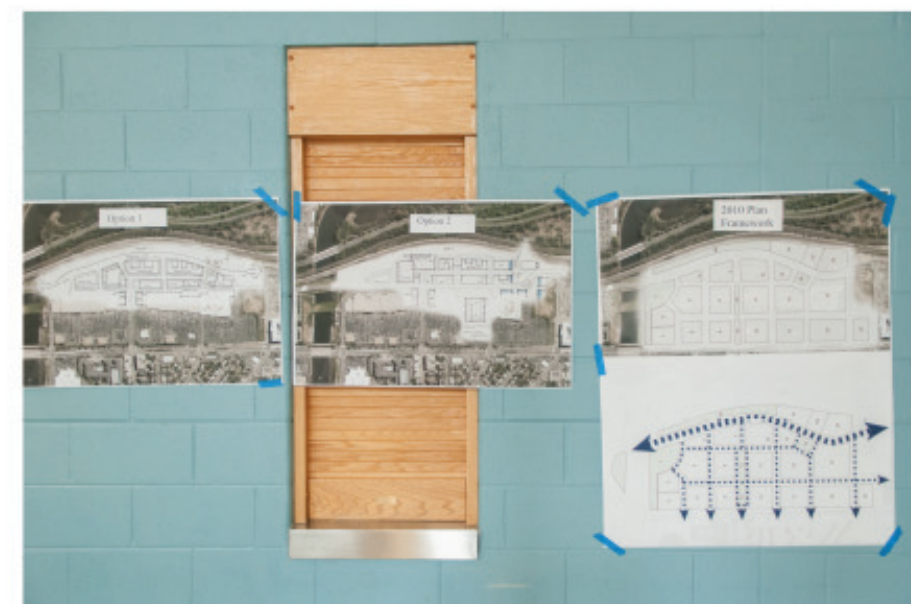
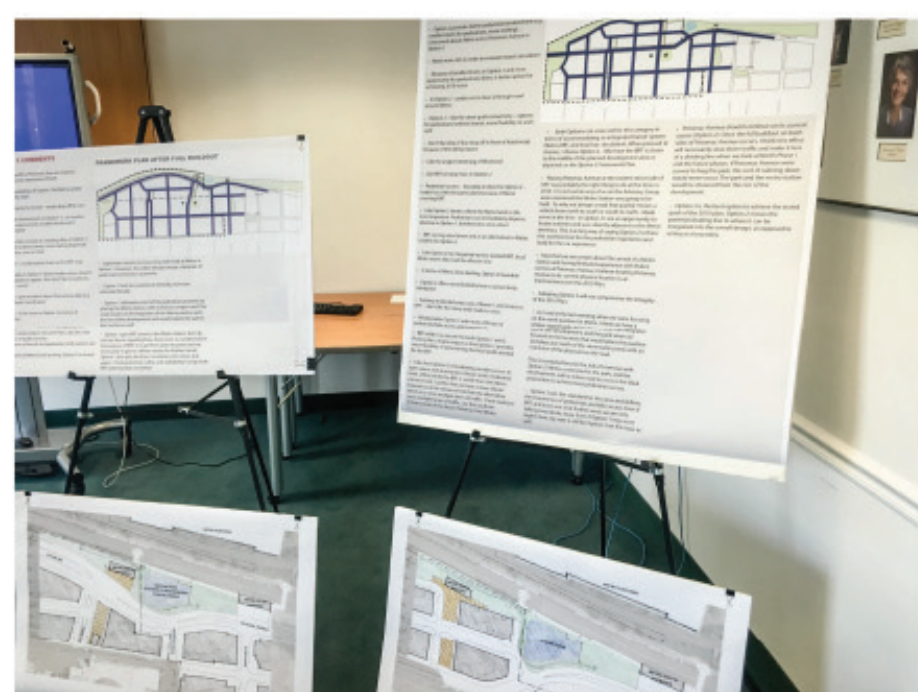
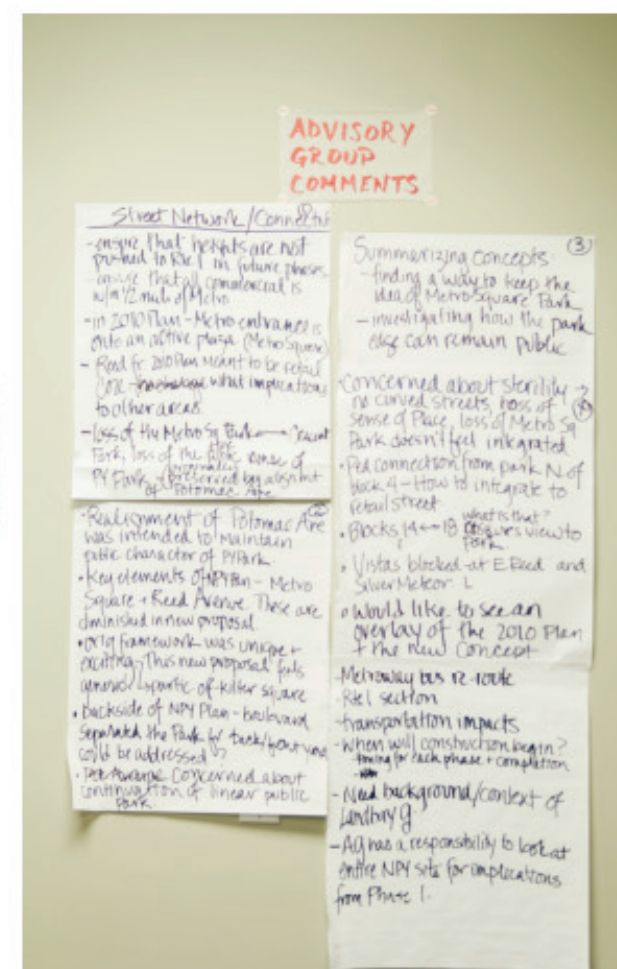
South entrance $\rightarrow$ long distance
of nature

North entrance $\rightarrow$ last overlap
most of office use

2N $\rightarrow$ seems like a fresh peak
experience $\rightarrow$ temporary

1 $\rightarrow$ Potomac is very wide

2N $\rightarrow$ minimizes work of street
crossing

$\rightarrow$ seems pedestrian-averse

2S $\rightarrow$ authentic relationship
everyday life

1 $\rightarrow$ doesn't feel experience
getting across Potomac
very close to car

2S $\rightarrow$ feels like a theater
coming off metro

2N $\rightarrow$ sensory experience
like why buildings wrap

1 $\rightarrow$ metro seems isolated
across Potomac is
 $\rightarrow$ what about bridging
across Potomac into looking
from on southeast
west side of Potomac Ave

fundamental question -
what do we want
Potomac Ave to be?

people will continue to use
Potomac Ave $\rightarrow$ design it
rather than walk
because it is

- further, make the officer work less
- 2N → provide good access thru video + sci
- 1 → you close off bus, but concern with bus of collecting info. how
- Like idea of BET dropping off more central to development
- 1 → 2S → like pend next to plaza

- Retail as a destination as you exit/enter the station
- 2N → option to connect to the park
- nice urban room
- good visibility coming in
- 1 → plaza could be done well
- 2's → ability to circulate vehicles
- 2N → a little issue of whether there is something to see coming down middle street
